Planning Commission
February 8, 2016 at 7:00 p.m.
Christine Nuernberg Hall
Mequon City Hall
11333 N. Cedarburg Road
AGENDA

ITEM #4 - P2 Development Company, Bob Bach /Lakeside Development

STAFF REPORT

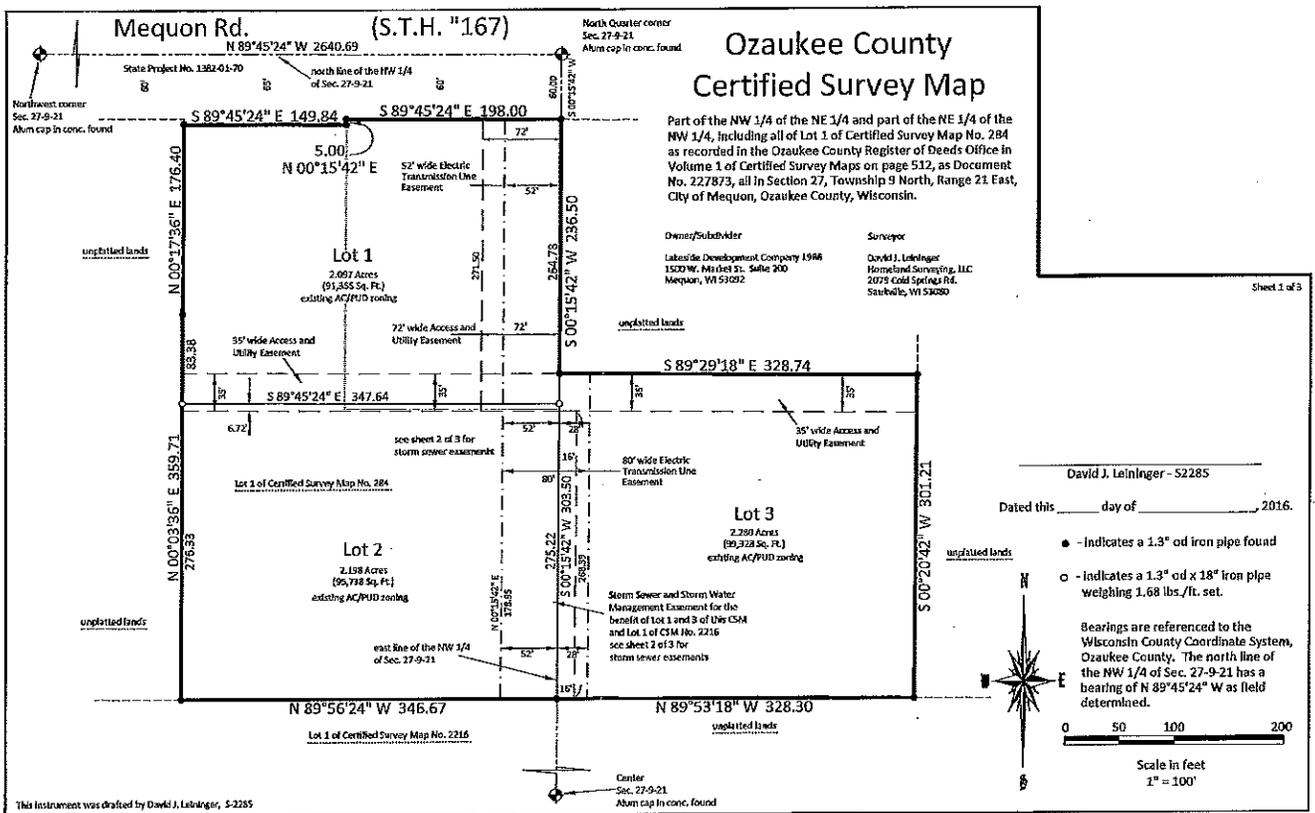
- ❖ This review pertains to a single sheet C-105, labeled "Landscape Plan". The proposed PUD use will be mixed commercial/Assisted Living/High Density Residential (Apartments); the proposed application will be required to demonstrate sensitivity to a number of pre-existing uses/conditions, including: adjacent proposed uses of the PUD; Town Center/PUD zoning, Interior Private Drives, fully developing a pedestrian walkway network, addressing removal of the site's existing trees, interior site buffering, parking buffering, signage, and lighting.

Planting instruction/commentary: Trees selected may meet caliper requirements, but failing to meet height requirements, or root ball size requirements will be rejected by the city. Clump form trees shall meet the equivalency requirements between the height and caliper. Ex: Per ANSI z 60.1, a 10-12’ tree is only equivalent to a 2.0” caliper tree. This reviewer recognizes that Ornamental trees may be display natural limiting height characteristics, the designer shall specify and, or select sizes that closest represents a 3.0” Caliper. The City of Mequon retains the right to reject trees for cause.

While the application is for a High Density Residential development, the plan equally meets, as well as, fails to meet the standard of care established for commercial development or the Town Center PUD landscaping standards in the City of Mequon. This concludes the landscape review of the Town Center Apartments Landscape submission.

1 SITE PLAN - LIGHTING PHOTOMETRICS
E100 SCALE: 1" = 20' - 0"

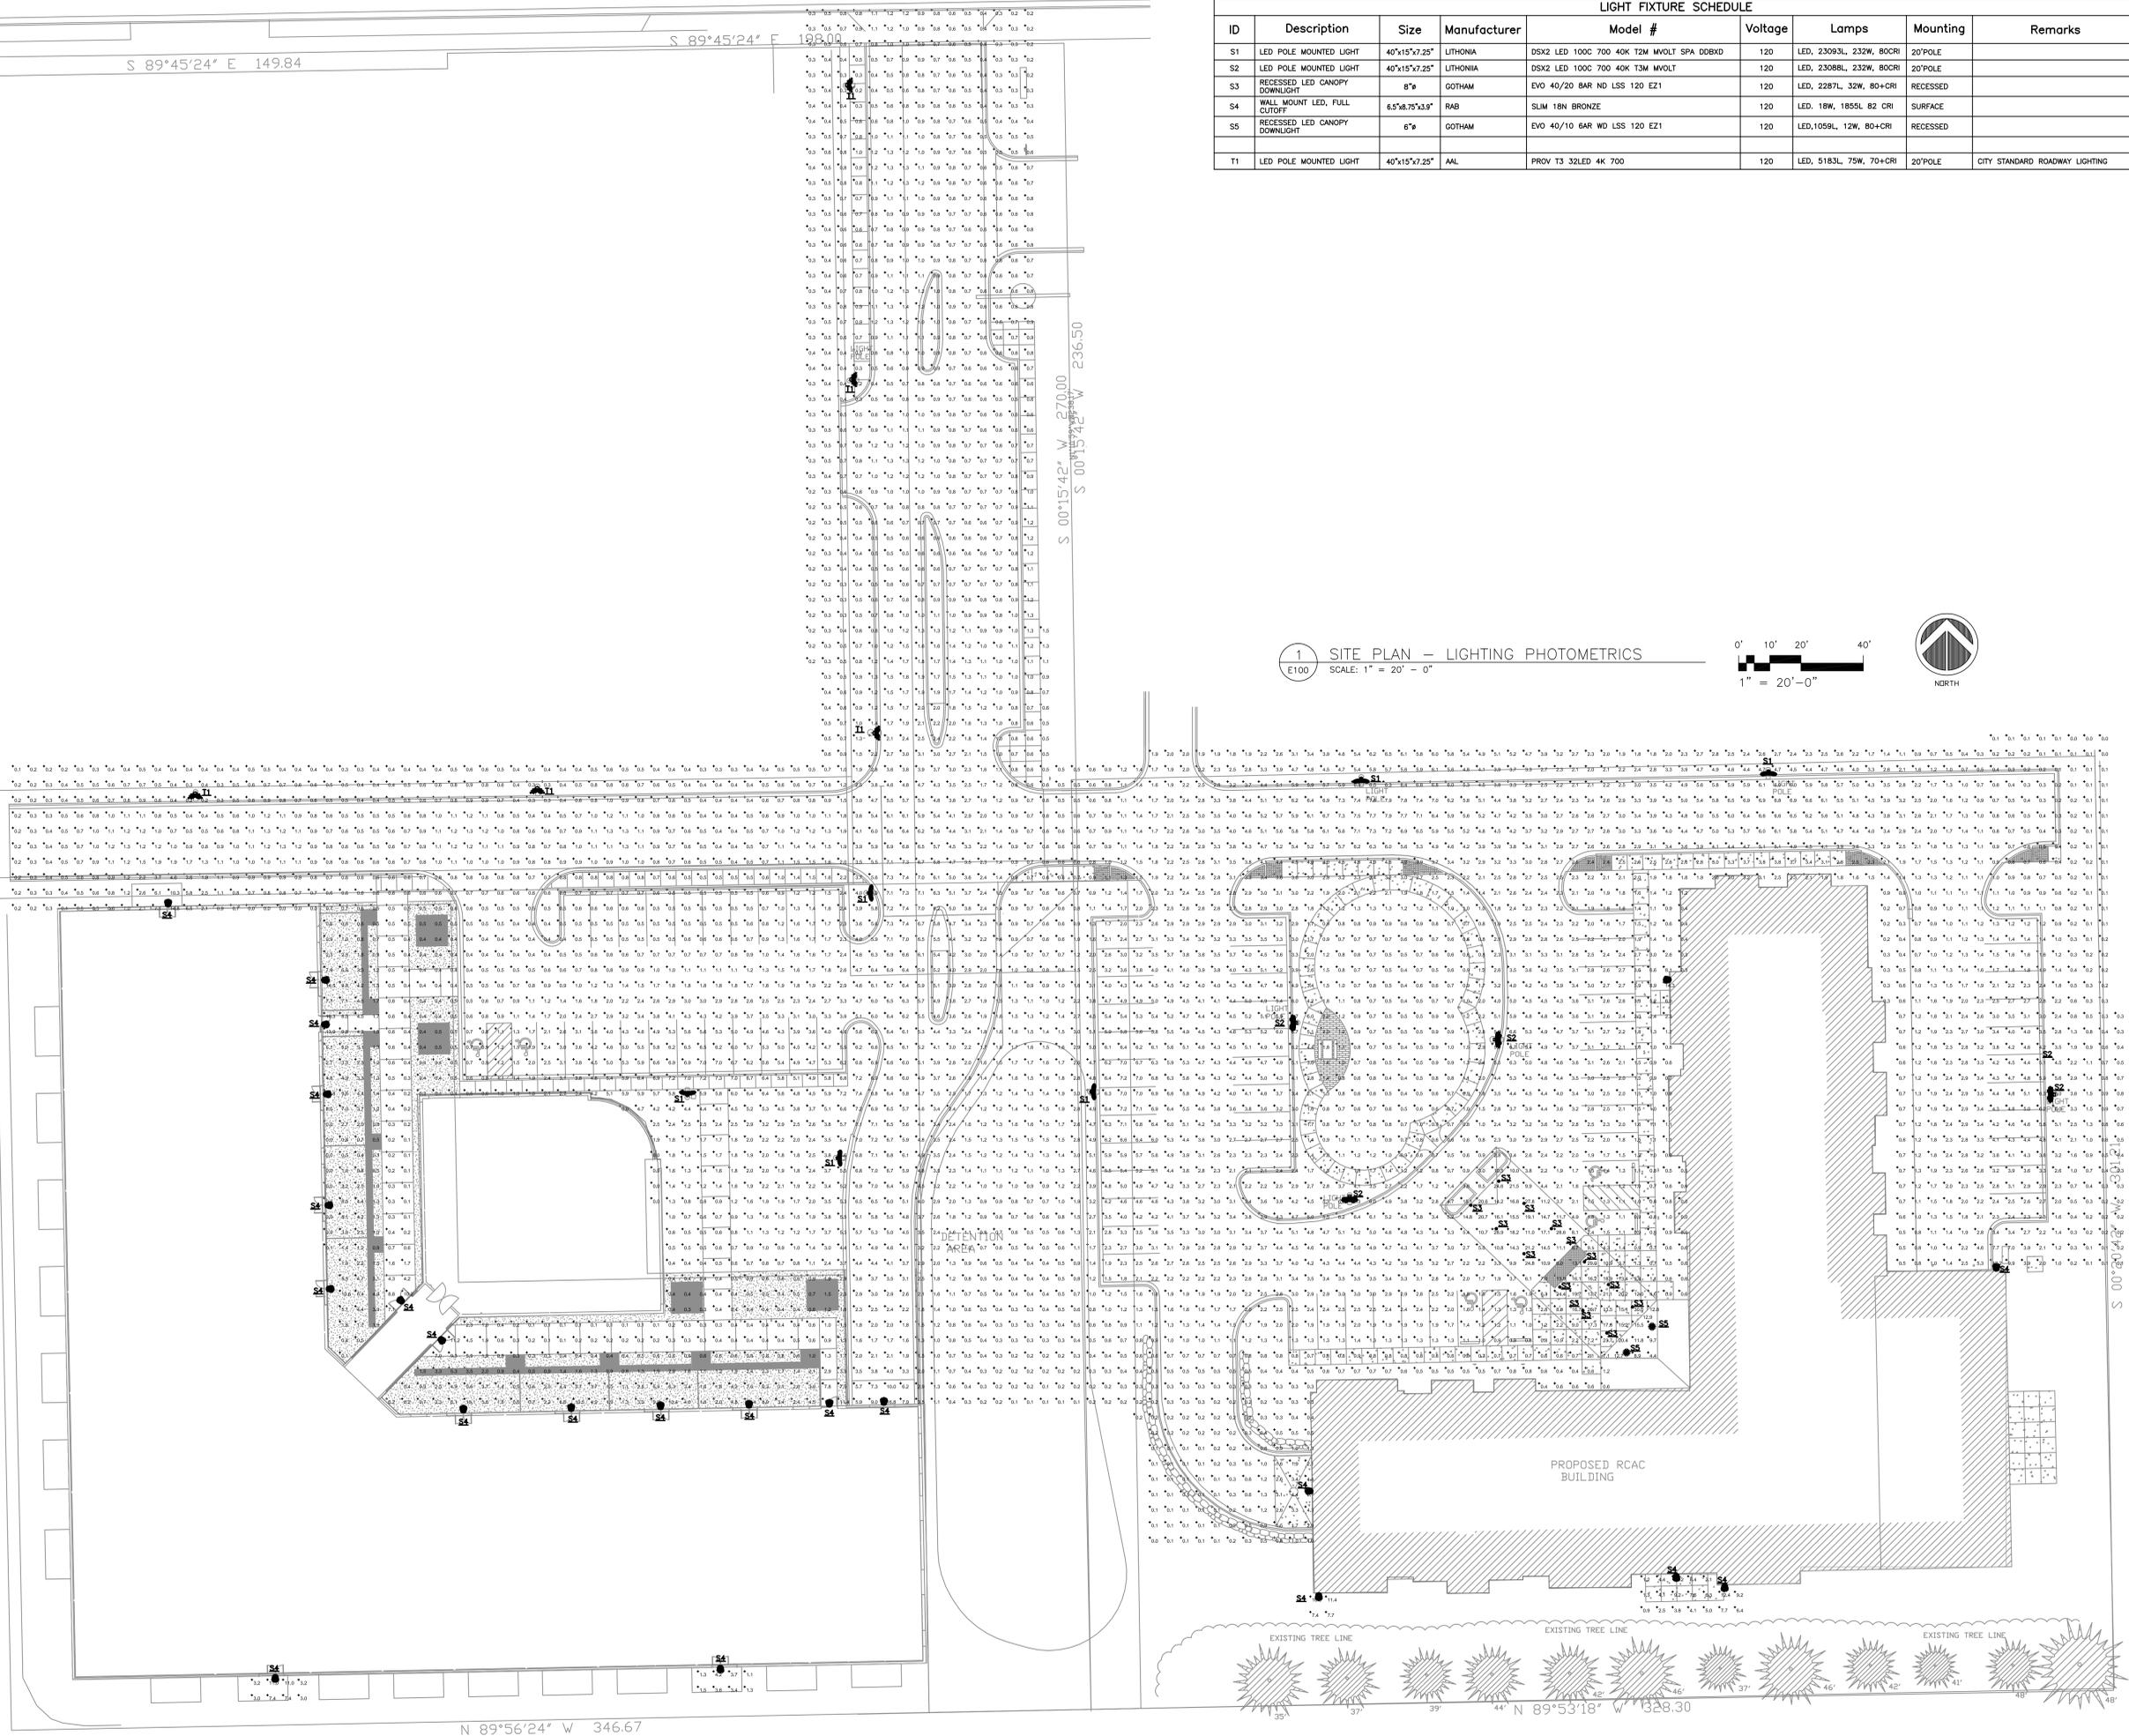
- Exit discharge lighting on the south elevation of the building exceeds 1.5 Fc.
 - The TC light fixture is used along the access road replacing the fixtures labeled S1 on the plan.

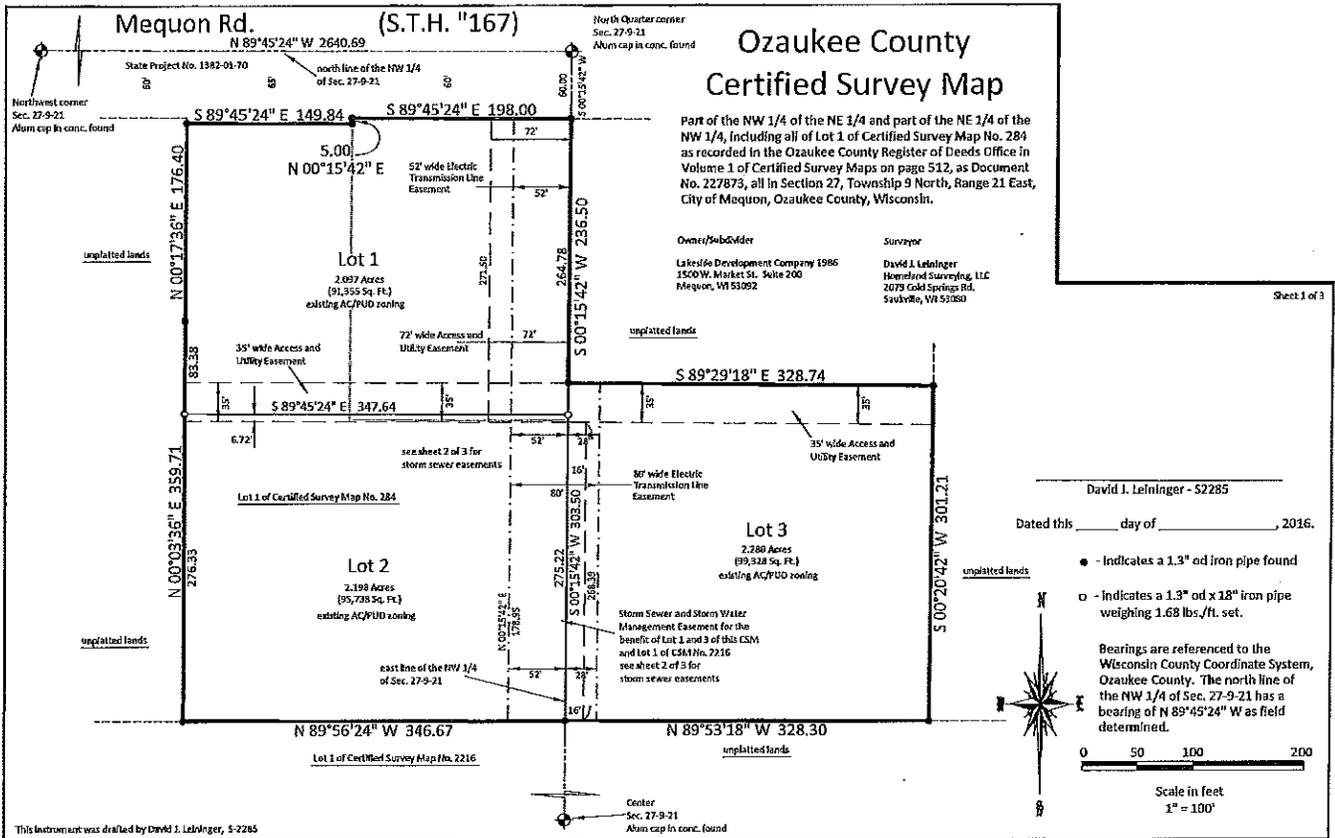
- ❖ This review pertains to a single sheet L-1.0, labeled "Landscape Plan". The proposed use is for a commercial/Assisted Living facility; the proposed application will need to demonstrate sensitivity to a number of pre-existing uses/conditions, including: Town Center/PUD zoning Intended use/at risk living facility, interior private drives & roads, Pedestrian systems, addressing informal ROW's street trees, addressing removal of the site's existing trees, interior site buffering, parking buffering, signage, and lighting.

- ❖ The plan detail 7/L200, notes for existing tree lines to be preserved; unfortunately, the same plan calls for 5-6' of regrading <cut> to take place in the same area. The noted existing trees/shrubs to remain in the proposed graded areas will be required to be removed. Remove the notes and add landscaping in the areas to be stripped by grading.

- Assign the plant symbols provided in the plant schedule, to the proposed landscape materials.
 - Provide the 3 year establishment and maintenance plan for the proposed Prairie within the plan set.

While the application is for a business/commercial use, the plan equally meets, as well as, fails to meet the standard of care established for business zoning landscaping in the City of Mequon. This concludes the landscape review of the Aster Assisted Living Landscape submission.
